LETTER OF TRANSMITTAL

SUBJ: Drainage Plan for Blanchat Machine Addition

DRAINAGE PLAN FOR BLANCHAT MACHINE COMPANY ADDITION **N.W.1/4, S. 25, T.27S., R.1W. OF THE 6TH P.M.** **WICHITA, SEDGWICK COUNTY, KS**

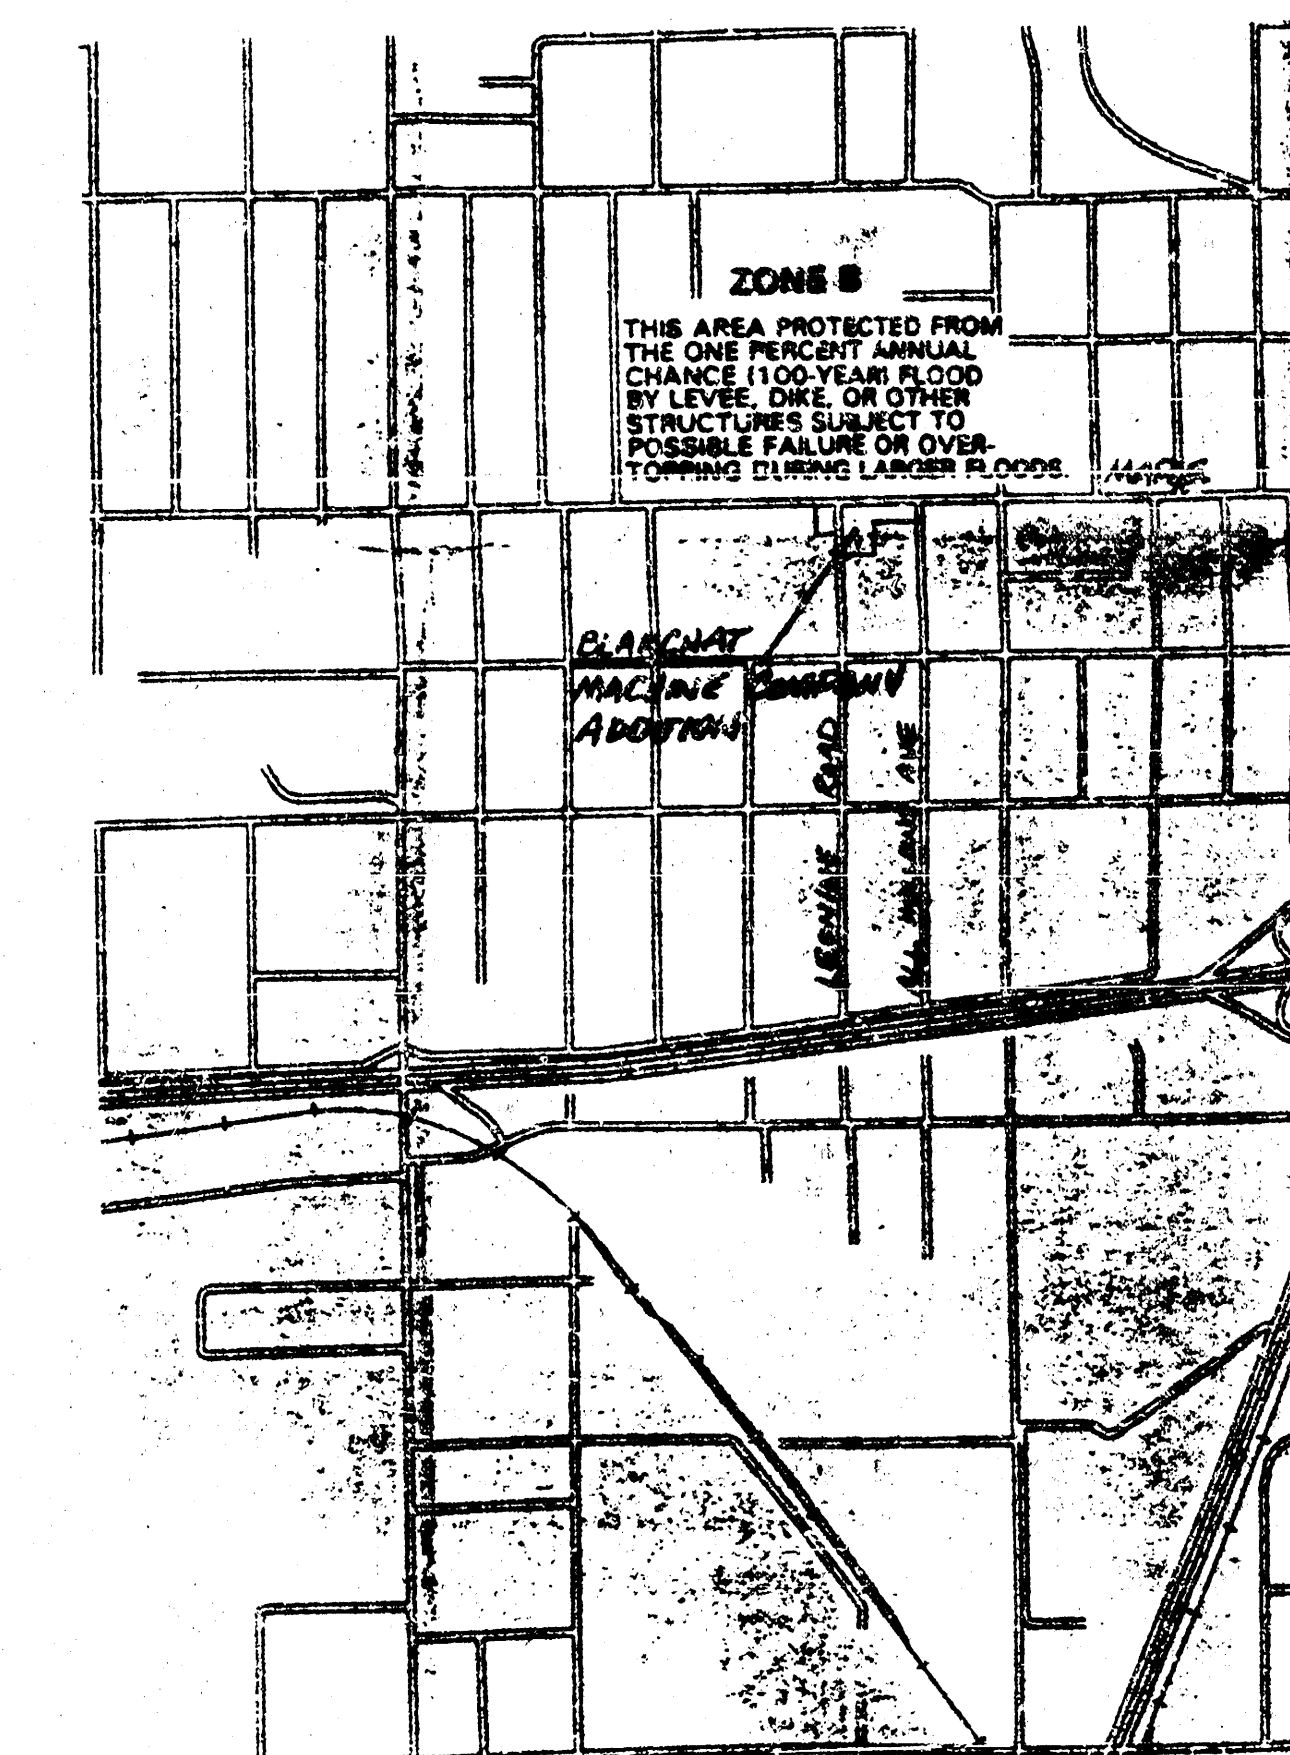
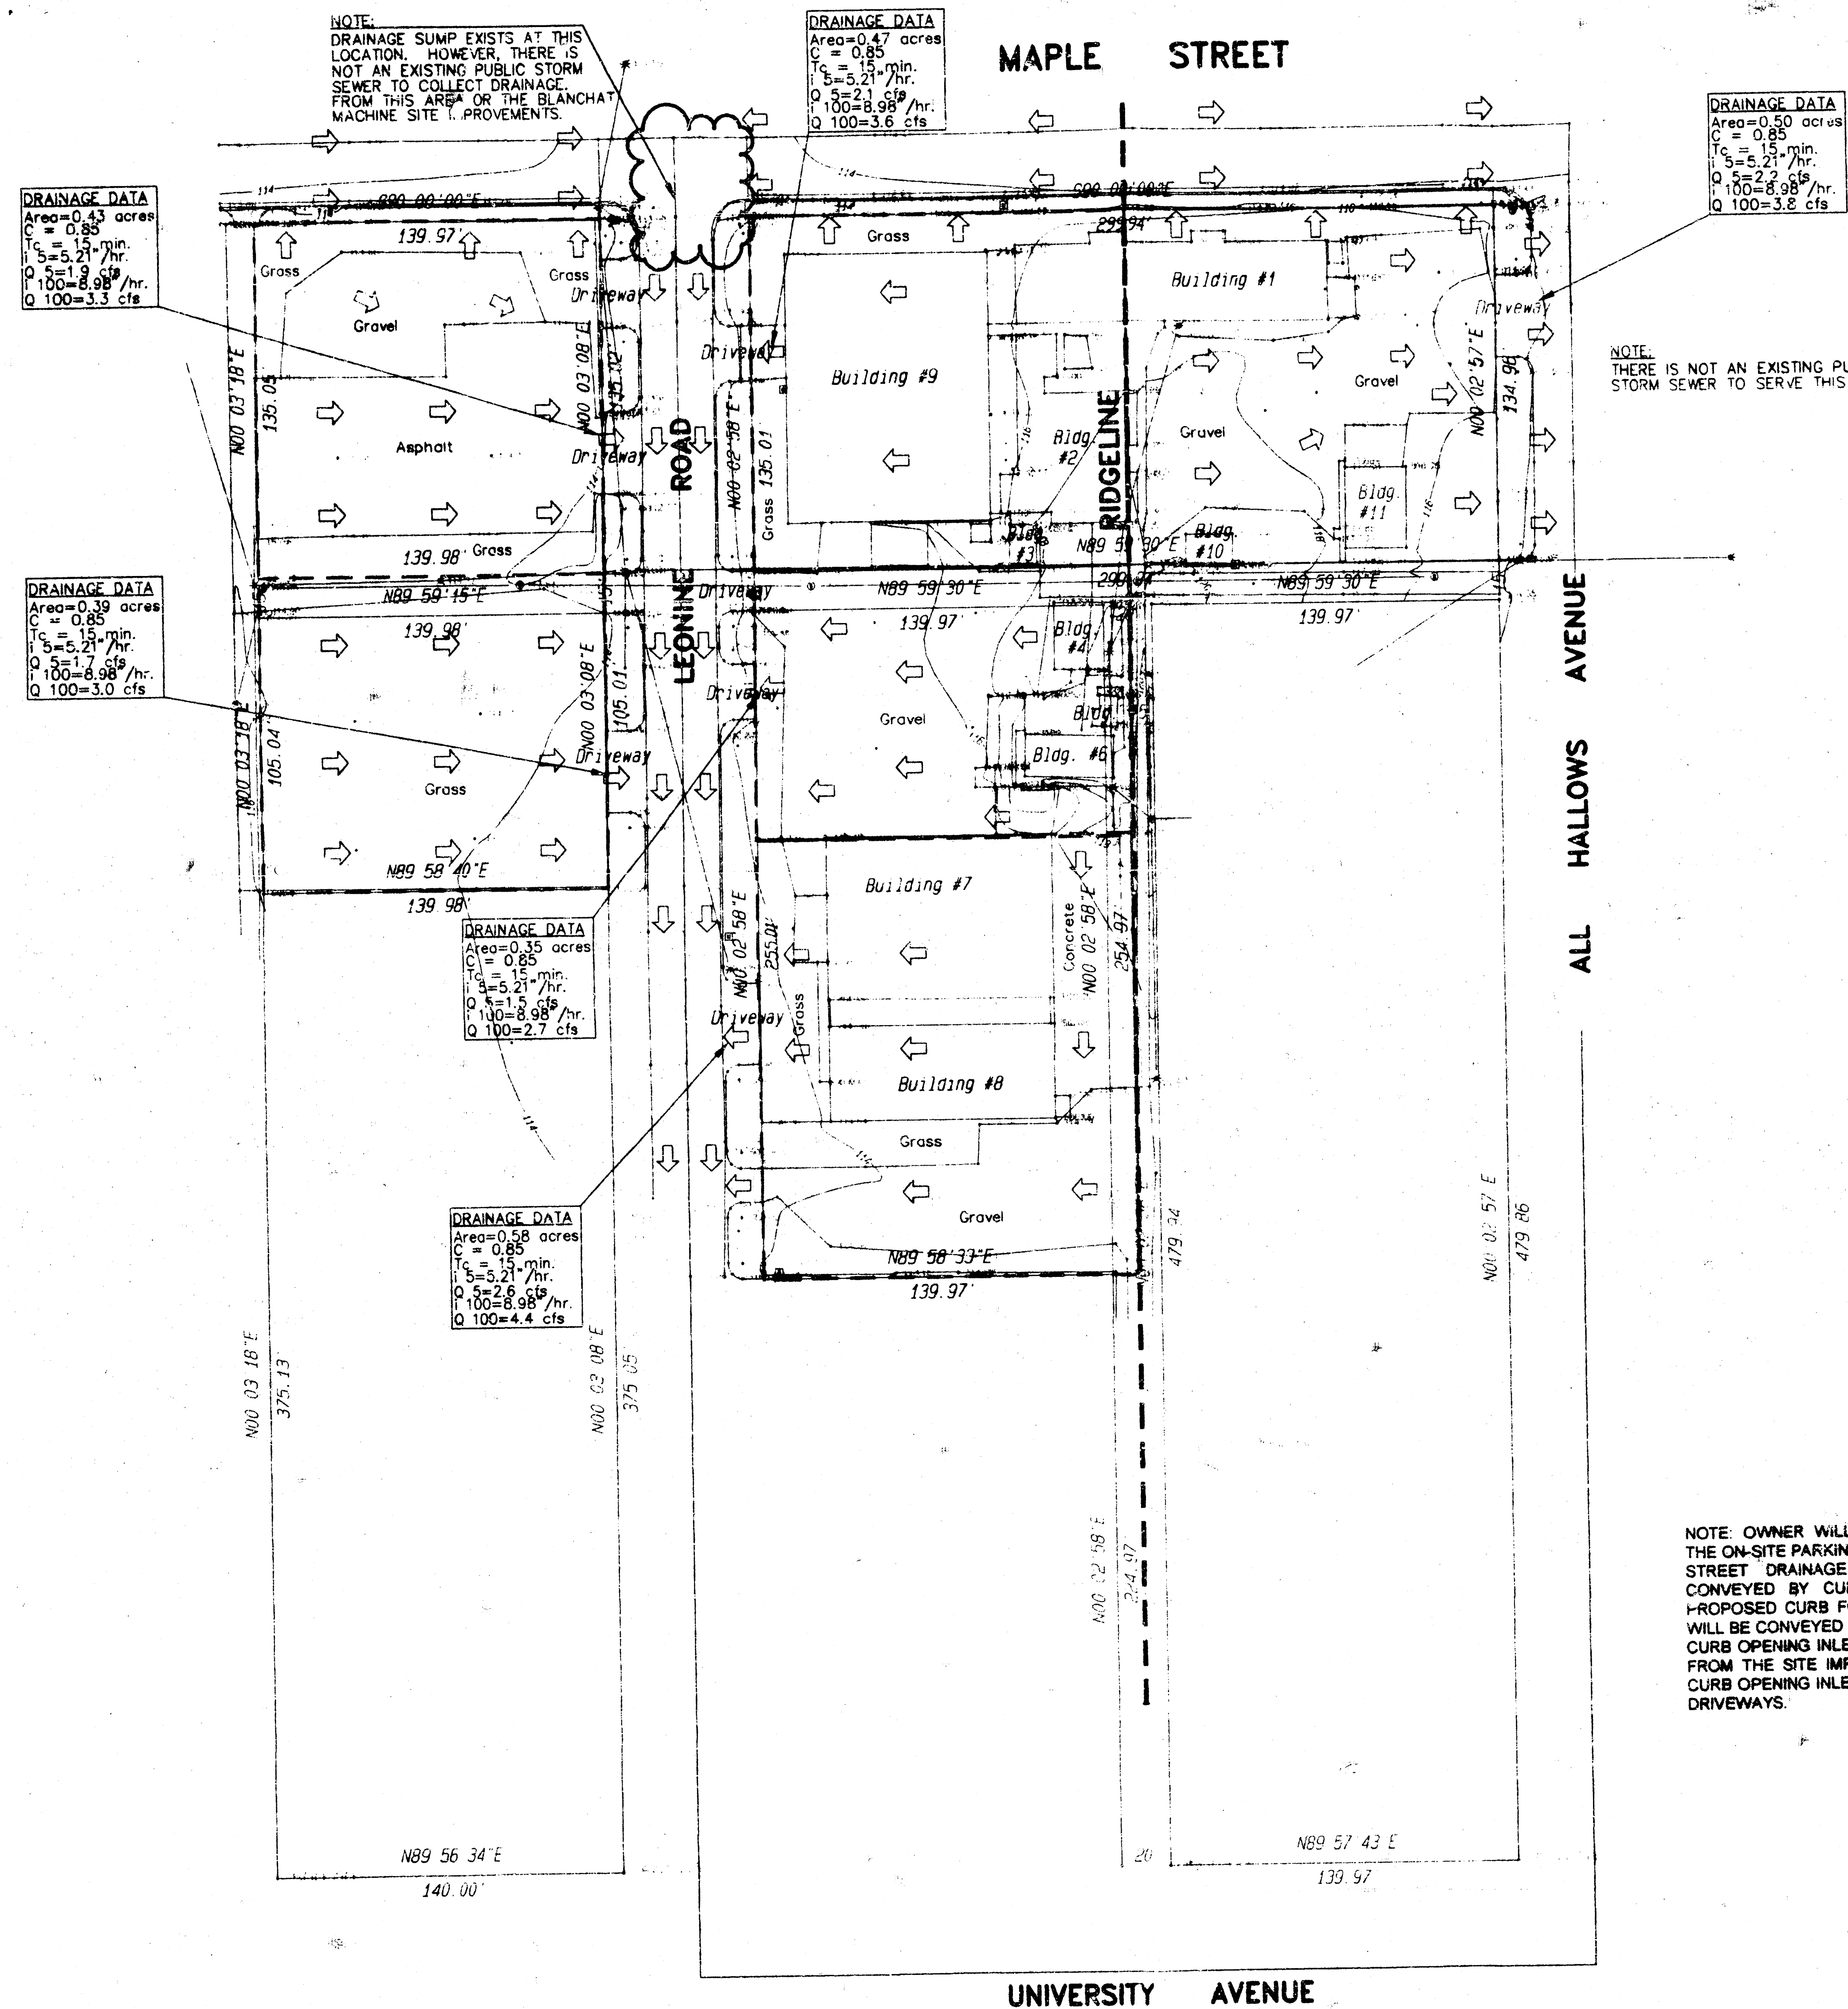
COMMENTS: Attached find the revised drainage plan for the above referenced addition. A note has been added to the drainage plan requiring on-site parking lot detention will be required when the site improvements are constructed.

NOTE: OWNER WILL IMPLEMENT DETENTION STORAGE INTO THE ON-SITE PARKING LOTS AND WILL RESTRICT FLOW TO THE STREET DRAINAGE SYSTEM TO THAT WHICH WILL BE CONVEYED BY CURB OPENING INLETS LOCATED IN THE PROPOSED CURB FOR THE ON-SITE PARKING LOT. RUNOFF WILL BE CONVEYED TO THE STREET CURB VIA 6" PVC PIPE AND CURB OPENING INLETS IN THE STREET CURB. THE DRAINAGE FROM THE SITE IMPROVEMENTS WILL BE DIRECTED TO THE CURB OPENING INLETS AND WILL NOT BE CONVEYED OUT THE DRIVEWAYS.
